UNITED STATES
NUCLEAR REGULATORY COMMISSION
WASHINGTON, D. C. 20555

Docket No. STN 50-480

SUBJECT: EXTENSION REVIEW MATTERS FOR PRELIMINARY DESIGN APPROVALS

FIG 1. PROPOSED DUCTILITY RATIO FOR BEAM-COLUMNS

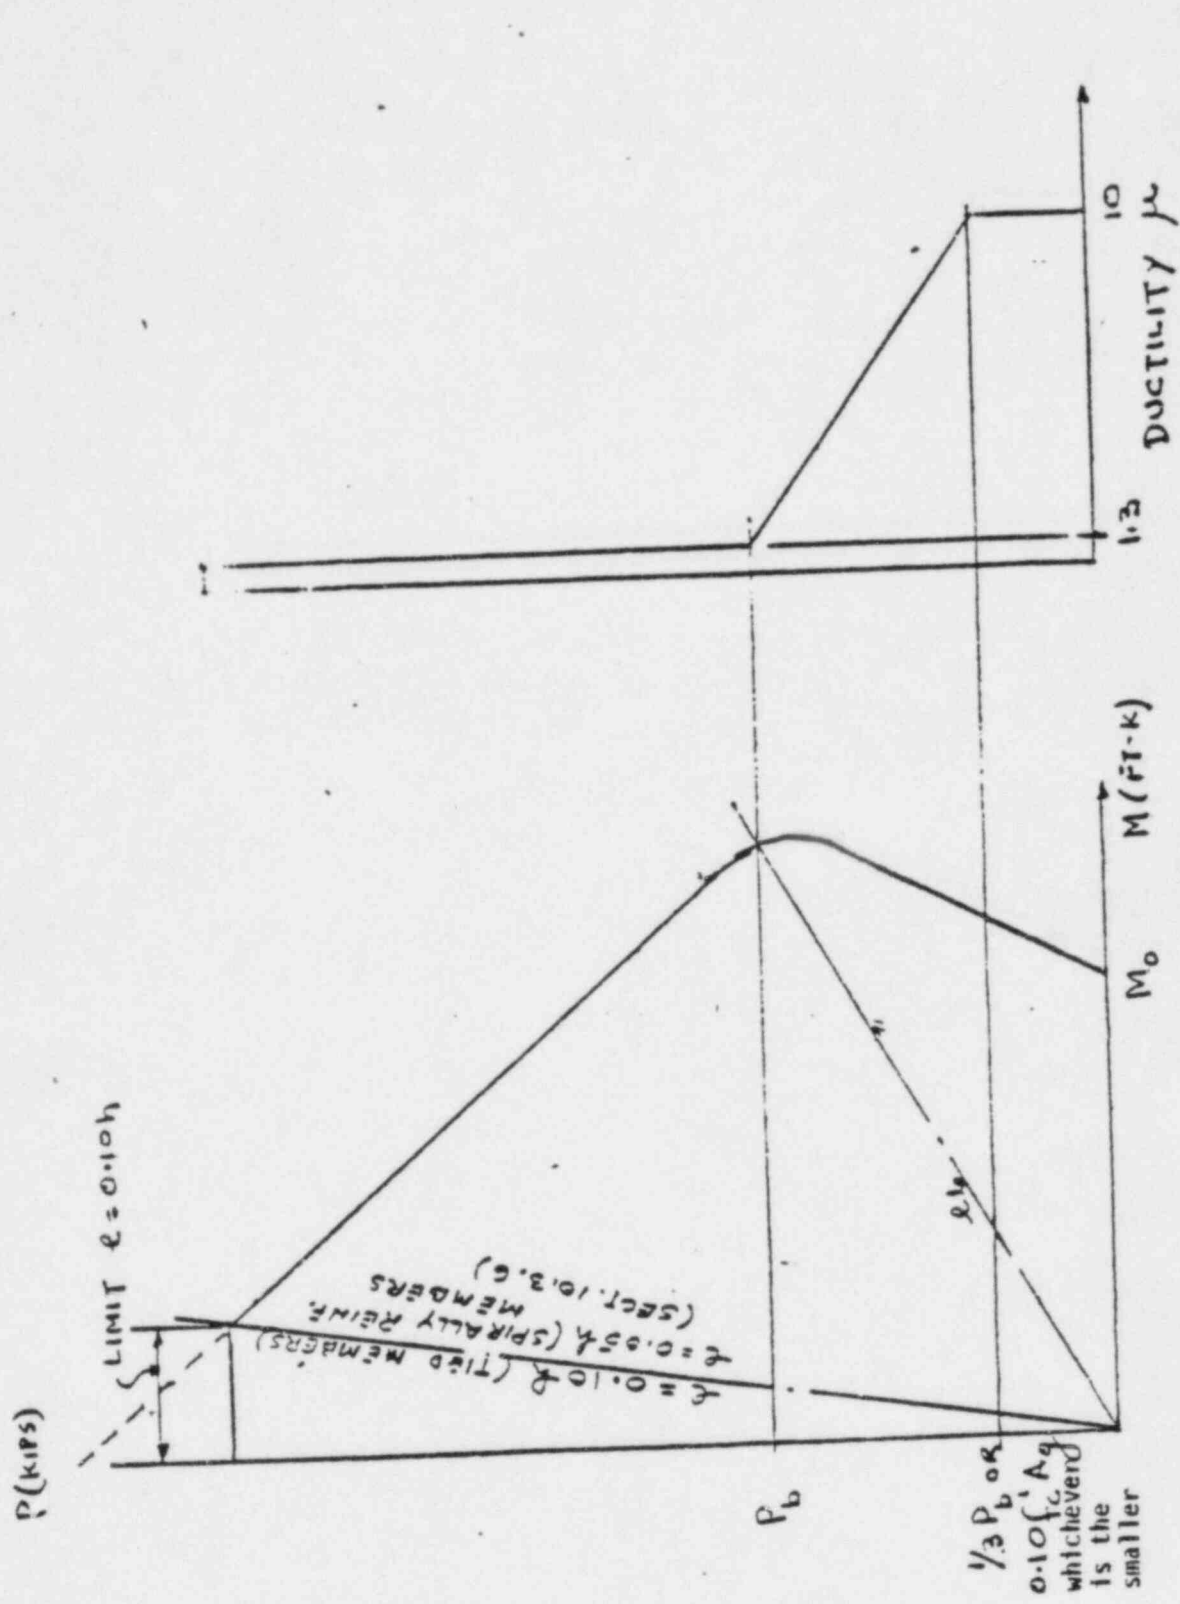
1.3 For beam-columns, walls, and slabs carrying axial compression loads and subject to impulsive or impactive loads producing flexure, the permissible ductility ratio in flexure should be as follows:

- (a) When compression controls the design, as defined by an interaction diagram, the permissible ductility ratio shall be 1.3.
- (b) When the compression loads do not exceed $0.1f_c'Ag$ or one-third of that which would produce balanced conditions, whichever is smaller, the permissible ductility ratio can be as given in Section 1.1.
- (c) The permissible ductility ratio shall vary linearly from 1.3 to that given in Section 1.1 for conditions between those specified in (a) and (b). (See Fig 1.)
